Filter fastening and removal: now included in the CAD

Original R02 preserved. Sources and reproducible commands: README.md beside this sheet. No prices, availability or physical results claimed.

FRONT STUD STACK / global y coordinates (mm); rear mirrored about y=180

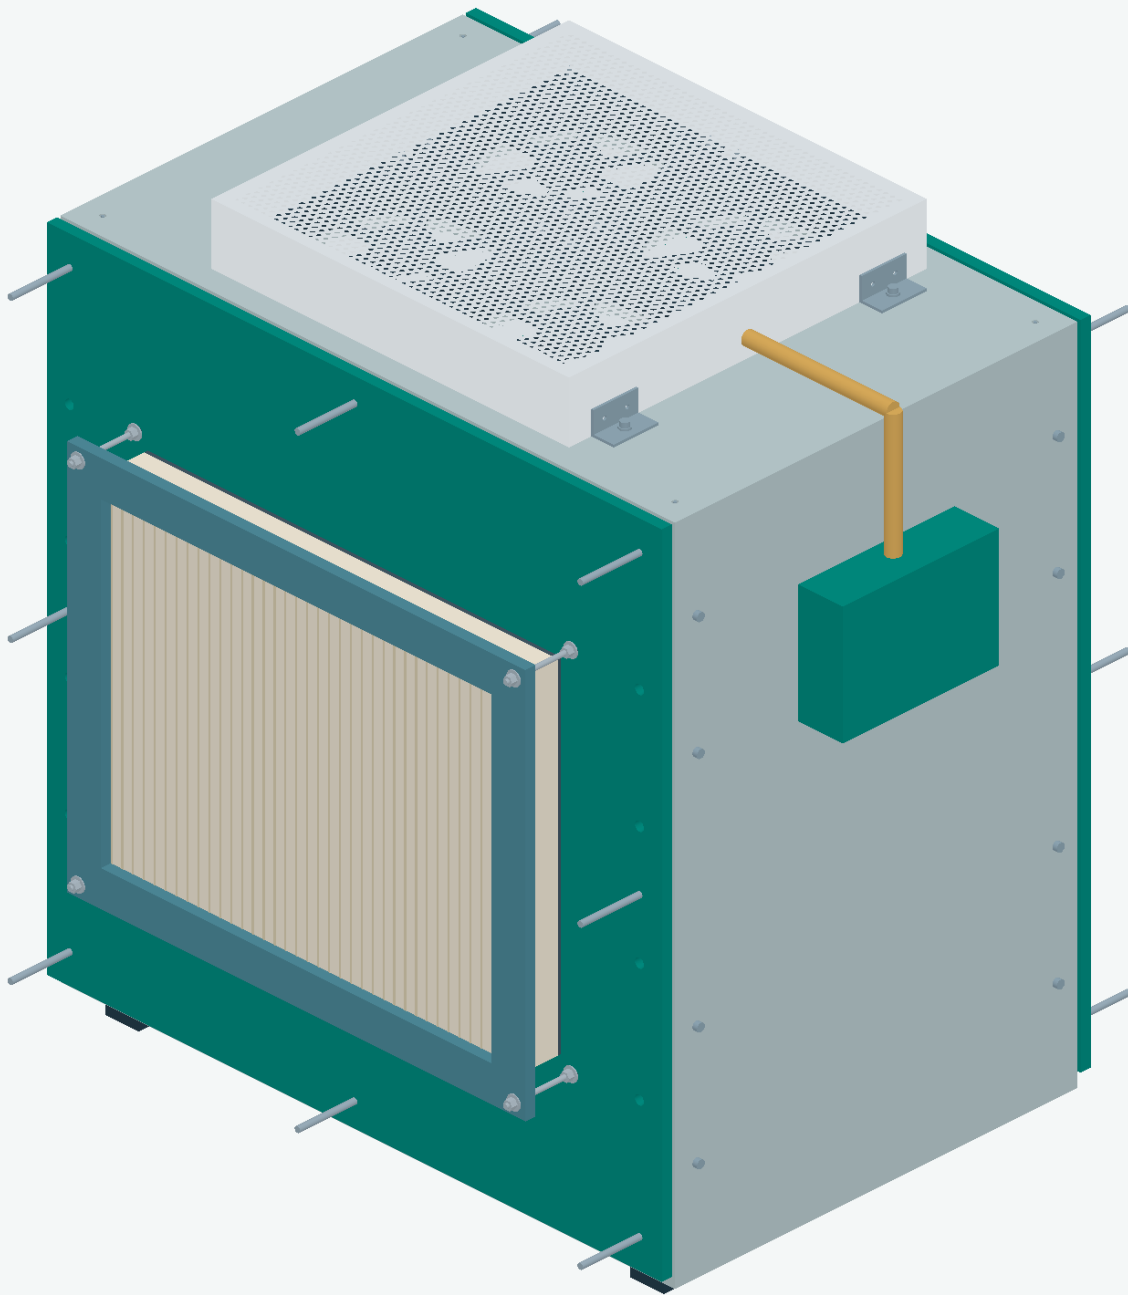
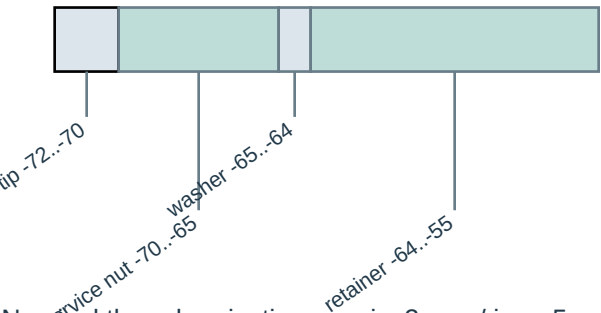
Normal thread projection: service2 mm / inner5 mm / ledge6 mm. Two-pitch1.4 mm comparison is an assumption, not a release criterion.

CHANGED: eight 70 mm rod envelopes replaced with proposed M4 x80 studs. Four ledge screws now have25 mm under-head length and modeled cap heads. Added28 nuts and32 metal backing washers.

SERVICE CHECK: after removing the four service nuts, washers and retainer on each side, the filter has a nominal200 mm straight outward travel without collision. Isolate power and wait for fans to stop before access; protective access controls remain unresolved.

ASSUMPTIONS: nut7 mm across flats x5 high; washer12 OD x4.3 ID x1; installed sealing washer1 mm. Gasket compression, filter border, tool/hand access and manufacturing tolerances are not verified.
